Harrell Stream and Wetland Mitigation Site
As-Built Baseline Monitoring Report

Harrell Stream and Wetland Mitigation Site
NCDMS Contract No. 007006
NCDMS Project No. 100005
DWR# 20161077
USACE Action ID: SAW-2016-02202
Jackson County, North Carolina
Data Collected: November 1st, 2019 – January 22nd 2020
Date Submitted: February 7th, 2020

Subject: Draft As-Built Baseline Monitoring Report (Task 6)
Harrell Stream & Wetland Site, Jackson County
Little Tennessee River Basin – CU 06010203 – Jackson County
DMS Project ID No. 100005
DEQ Contract #007006

Figure 2
 Assets Map
 Harrell Mitigation Site
 Jackson County, NC
 January 15, 2020

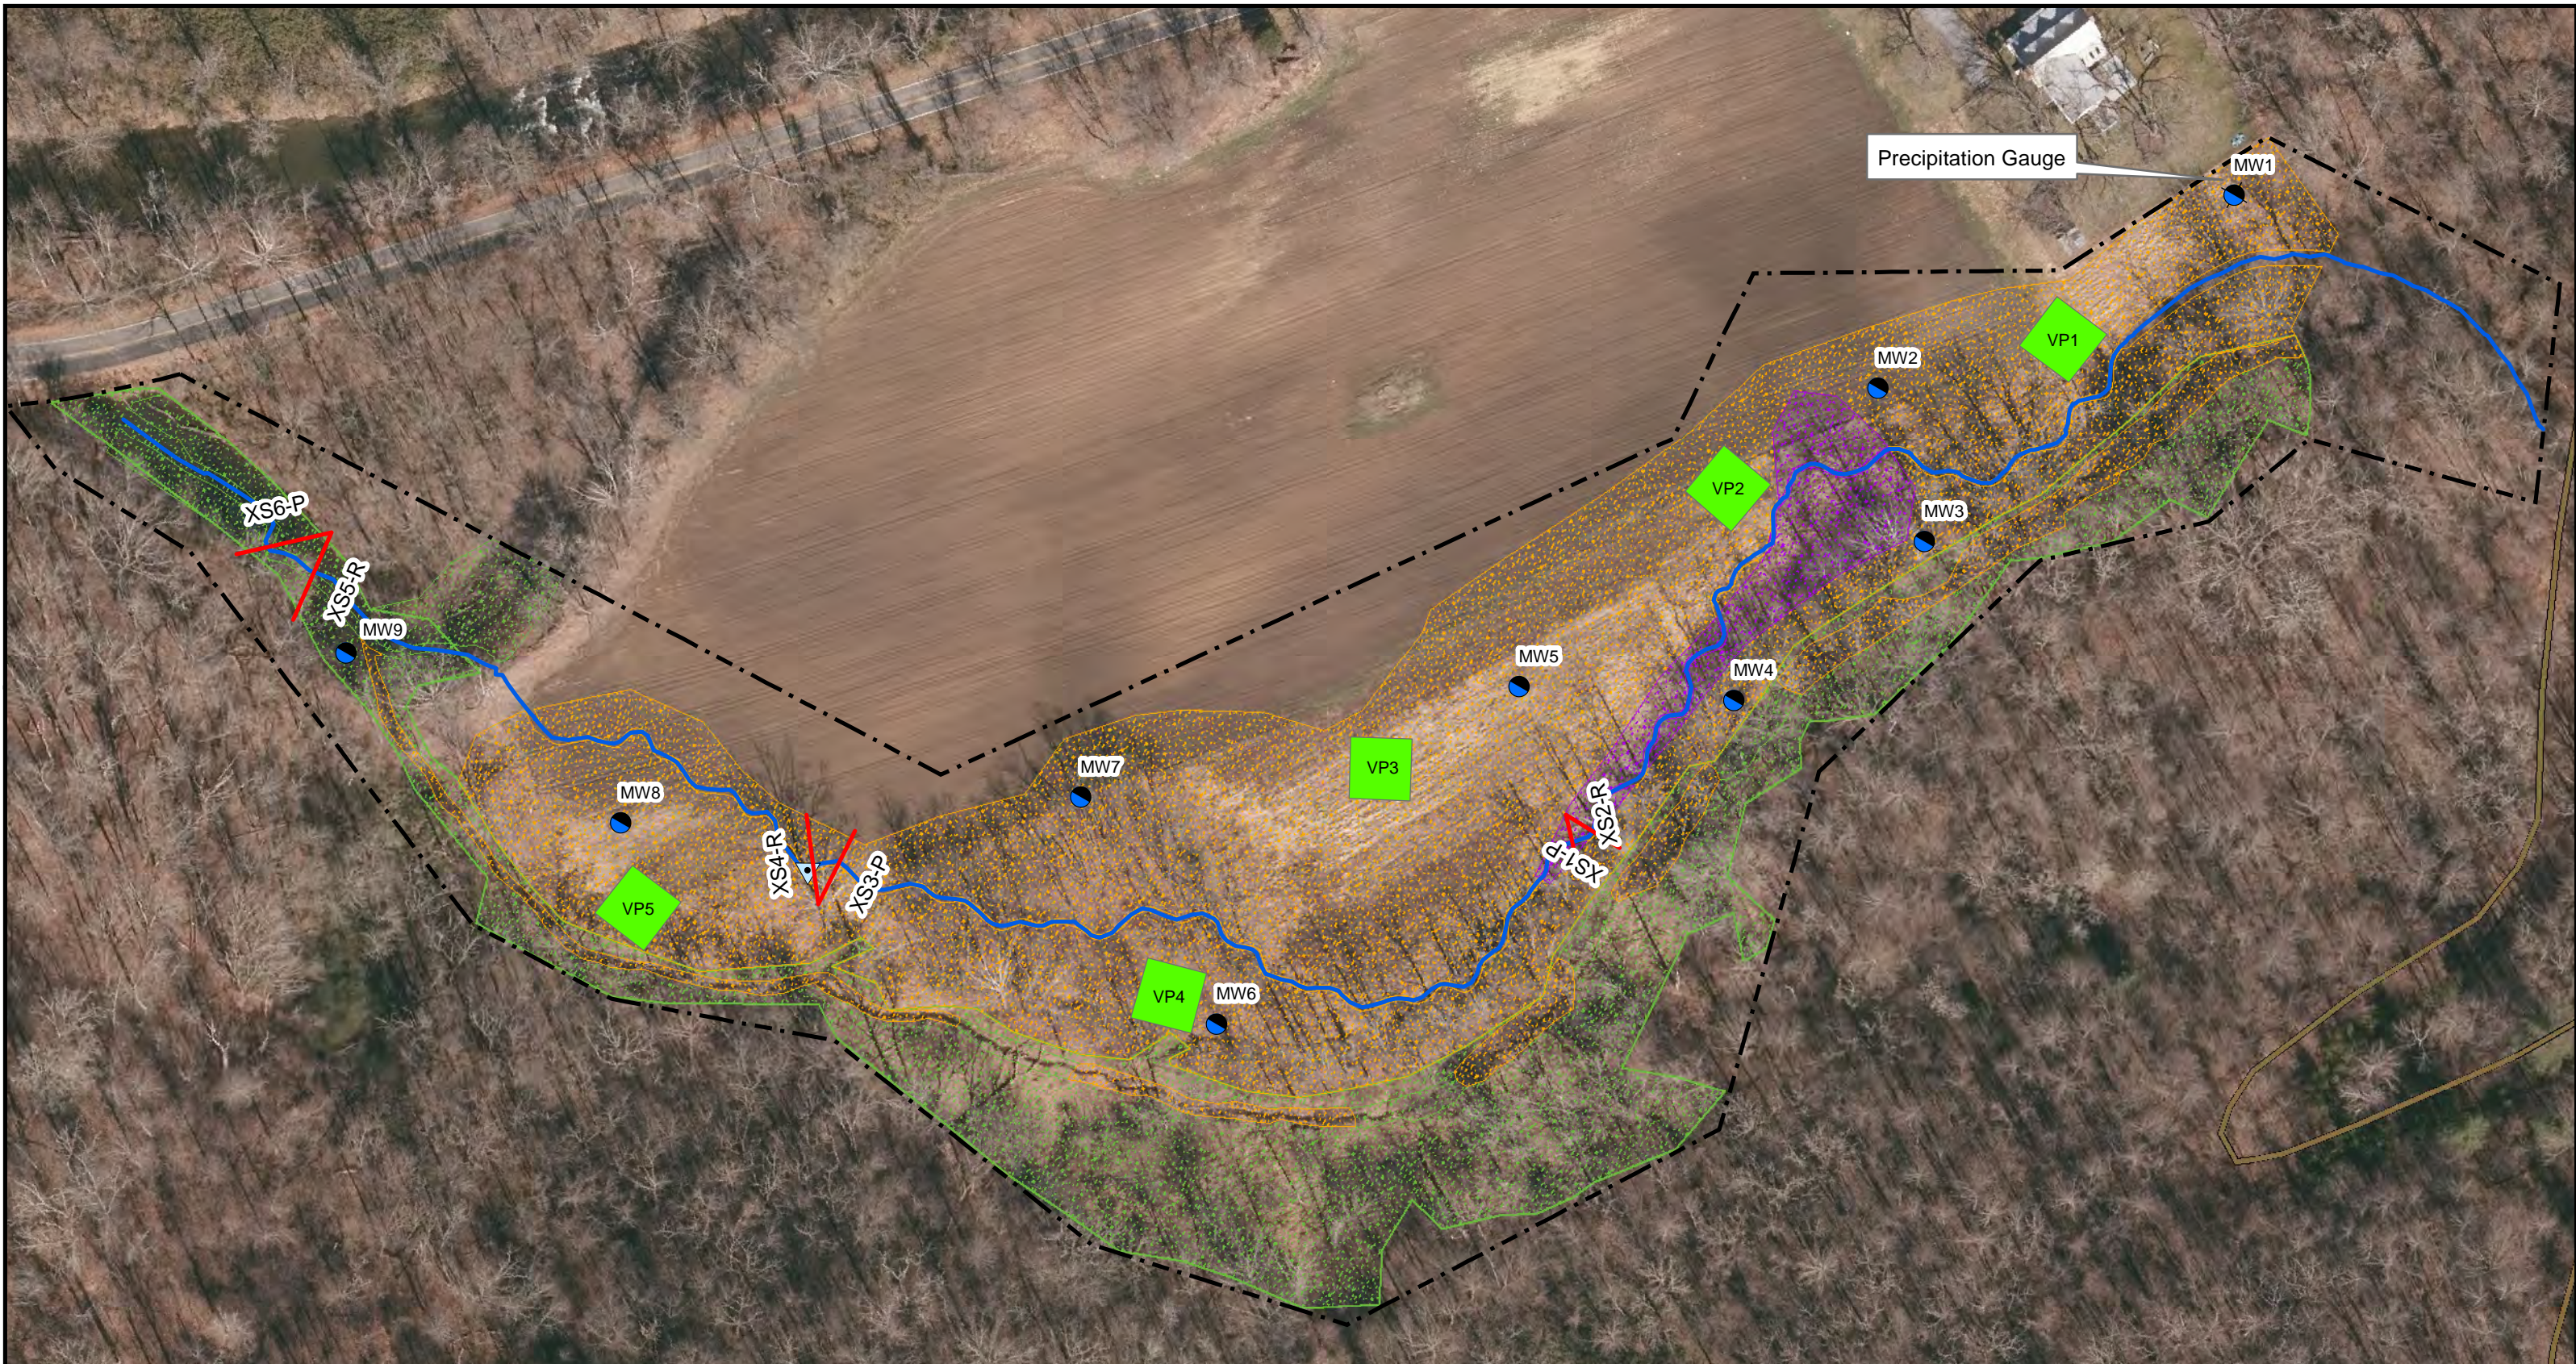
Figure 2: Please include reach breaks in the legend for clarity. Recommend bringing the stream layer to the top of the GIS stack for better map clarity. Please include the wetland rehabilitation feature identified in Table 1 on the figure and in the legend. The wetland rehabilitation shape should also be included in the revised digital support files. **Breaks are now included in map legend; map features were layered accordingly for better visual clarity; rehabilitation feature was added to map & legend.**

Figure 3
 Monitoring Features Map
 Harrell Mitigation Site
 Jackson County, NC
 January 15, 2020

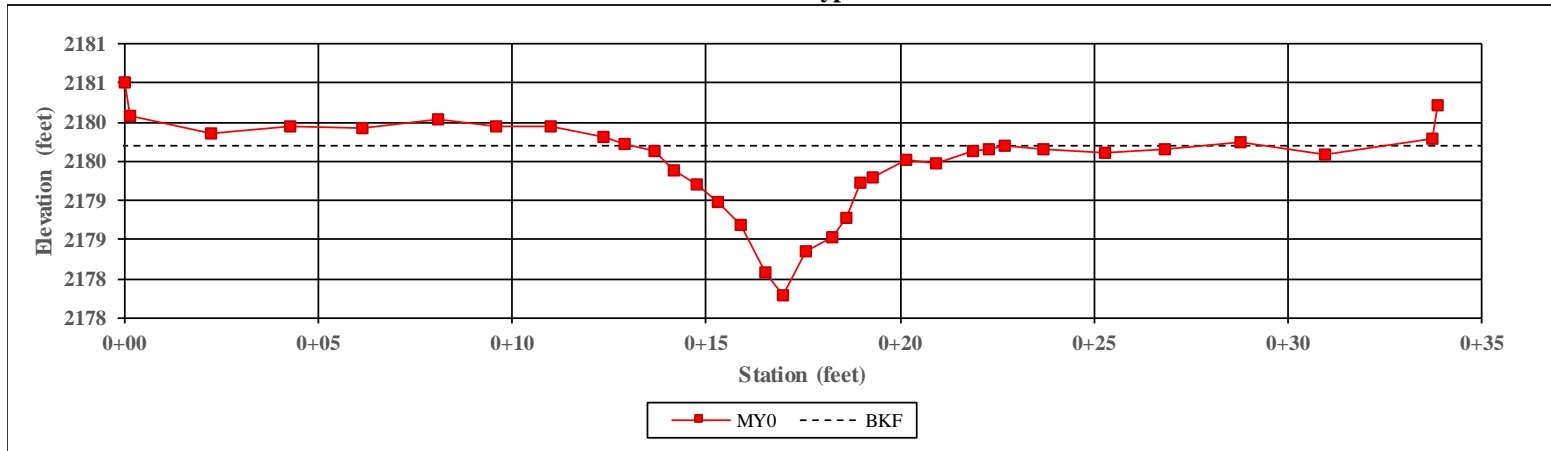
Figure 3: Please include the wetland rehabilitation feature identified in Table 1 on the figure and in the legend. **Rehabilitation feature was added to map & legend.**

Figure 3: The legend symbol for the continuous stage recorder does not appear to coincide with what is shown on the map. Please QA/QC and update the map as necessary. **Map & legend updated for consistency.**
